## PERMIT MODIFICATION APPROVAL

Re: Permit Modification Approval for API Number 9101293, Well #: DUNHAM 6H

**Re: Triana Energy, LLC – Well Plat Modification Requests  
Dunham 2H, 4H and 6H Horizontal Wells, Booth's Creek District, Taylor County, WV**

# DUNHAM LEASE DUNHAM 6H

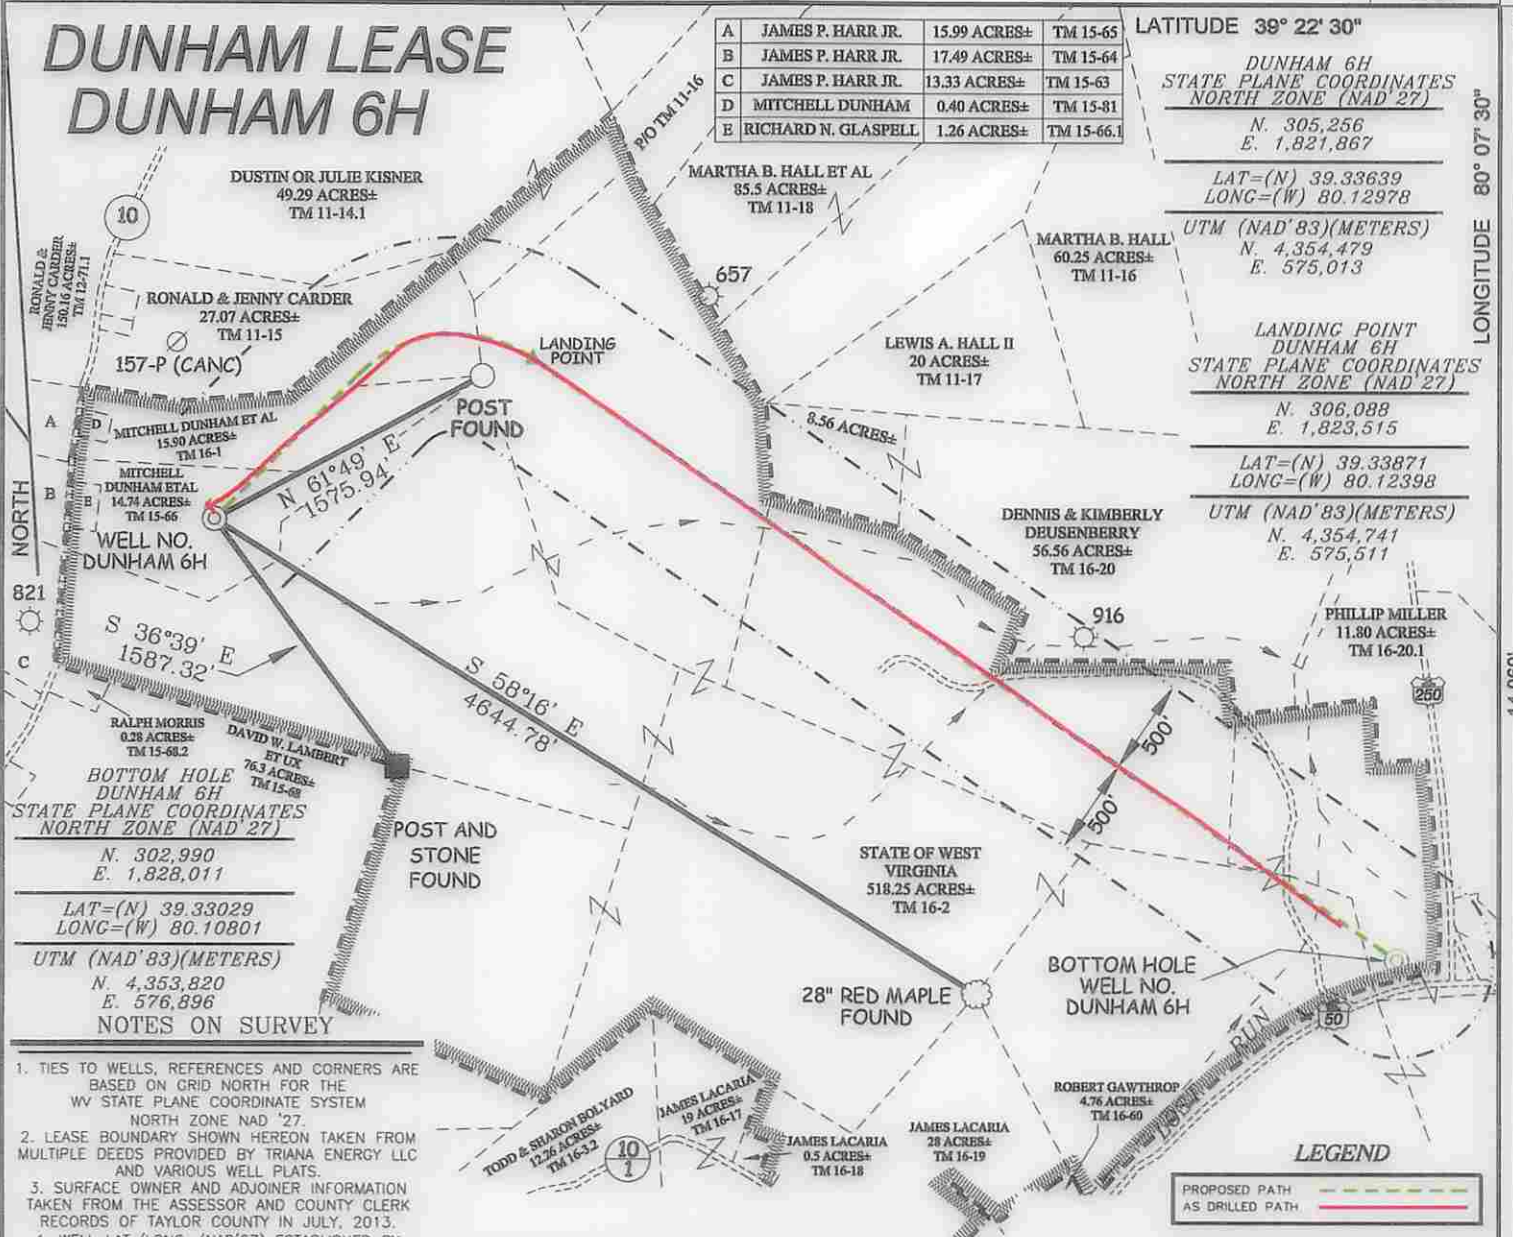
Upon completion of as-drilled plats for its Dunham 2H, 4H and 6H horizontal natural gas wells drilled in Booth's Creek District, Taylor County, West Virginia, Triana Energy discovered that the surface location of each well was inadvertently relocated exactly 30 feet south from their permitted locations. Triana has conducted an exhaustive investigation to determine the cause of the relocation, however no conclusion was reached. The well pad was originally designed to accommodate six wells, but was later reduced to five wells, due to mineral lease constraints. Inasmuch as the approved well locations are spaced 30 feet apart, we can only presume that an error occurred in stakeout during the transition from six wells to five wells.

In any event, Triana apologizes for any inconvenience and hereby requests that the well permits and records for the three wells are modified to reflect the accurate surface hole locations. Corrected plats for the wells are included herewith. Mylar plats were submitted to your office with corrected WR-35 Completion Reports.

6. AS DRILLED INFORMATION PROVIDED BY TRIANA ENERGY, LLC.
  7. TOP HOLE AS DRILLED COORDINATES DETERMINED BY BISECTING STEEL PLATE COVERING CELLAR.
  8. THIS PERMITTED PLAT REVISED TO SHOW THE AS DRILLED PATH AND COORDINATES RELATIVE TO THE PROPOSED WELL.

NAD'27 S.P.C.(FT)	N. 305,288	E. 1,821,868
NAD'27 GEO.	LAT-(N) 39.33648	LONG-(W) 80.12978
NAD'83 UTM (M)	N. 4,354,489	E. 575,013
